## INJECTION WELL PERMIT APPLICATION

Well Name and Number: GM 239-36 API No: 05-045-14693  
 UIC Facility No: 159369 (as assigned on an approved Form 31)  
 Project Name: GM 239-36 Injection Well Operator Name: Williams Production RMT  
 Field Name and Number: Grand Valley 31290 County: Garfield  
 QtrQtr: NESW Sec: 36 Twp: 6S Range: 96W Meridian: 6th PM

**From:** Olson, Ryan [Ryan.Olson@williams.com]  
**Sent:** Wednesday, December 21, 2011 3:40 PM  
**To:** Onyskiw, Denise  
**Subject:** GM 239-36 WBS  
**Attachments:** GM 239-36 Wellbore Schematic.xlsx

**GM 239-36 Wellbore Schematic**

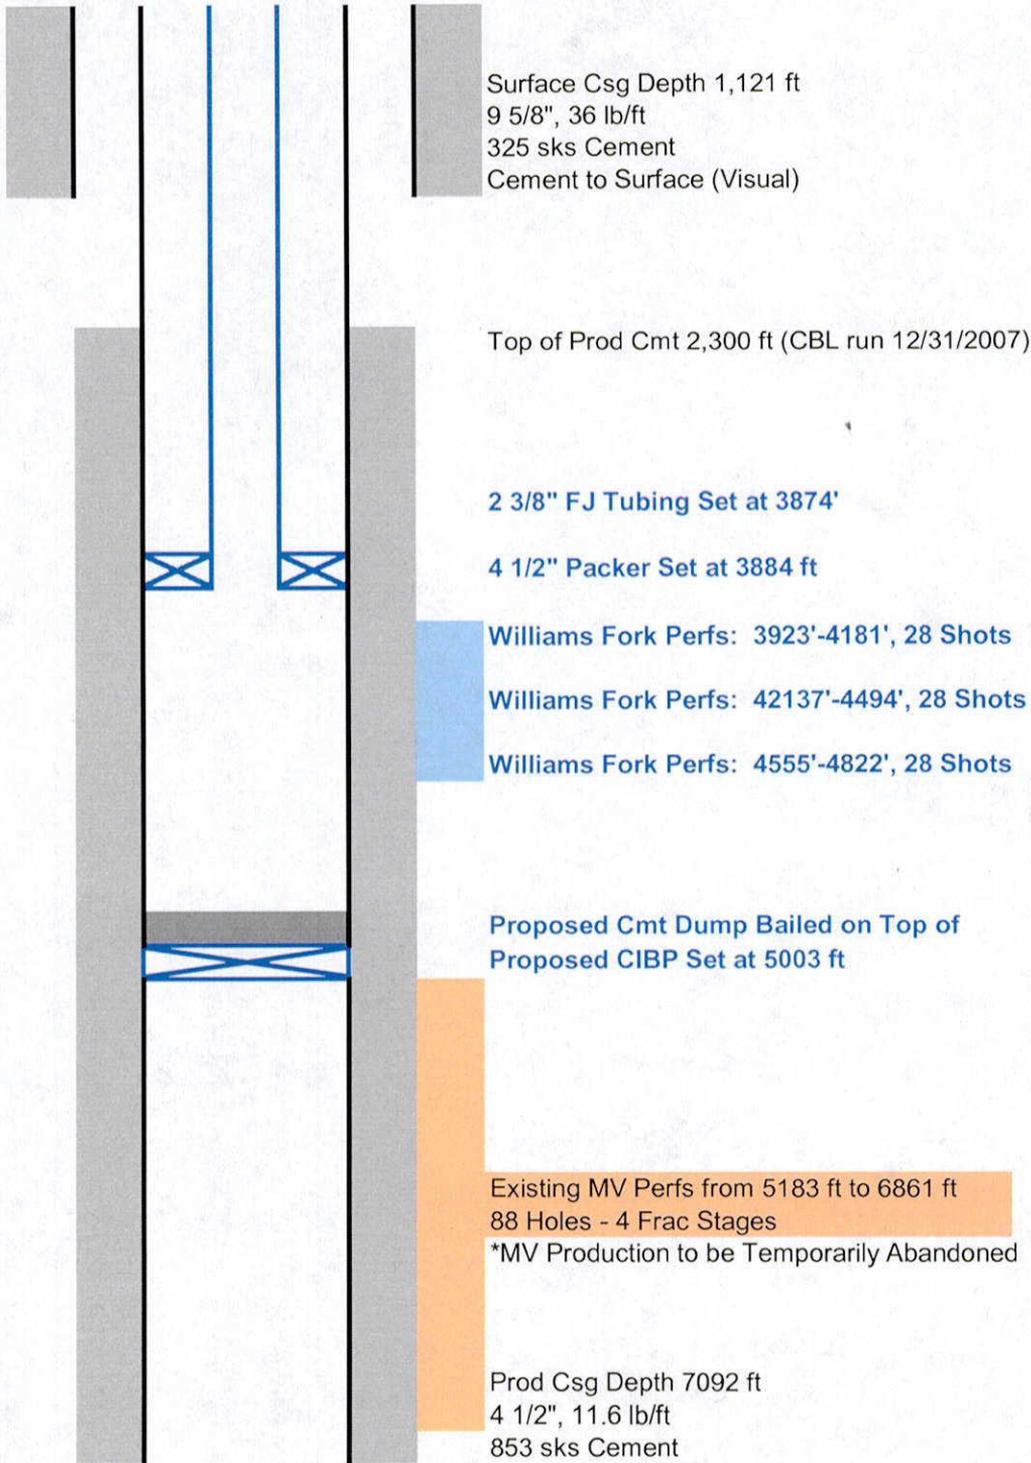
I updated the tubing, packer, perf and CIBP depths to match the actual. If you need any further information, please let me know

2 3/8" FJ Tubing Set at 3874'

4 1/2" Packer Set at 3884 ft

Williams Fork Perfs: 3923'-4181', 28 Shots

Williams Fork Perfs: 42137'-4494', 28 Shots

Williams Fork Perfs: 4555'-4822', 28 Shots

Proposed Cmt Dump Bailed on Top of  
Proposed CIBP Set at 5003 ft
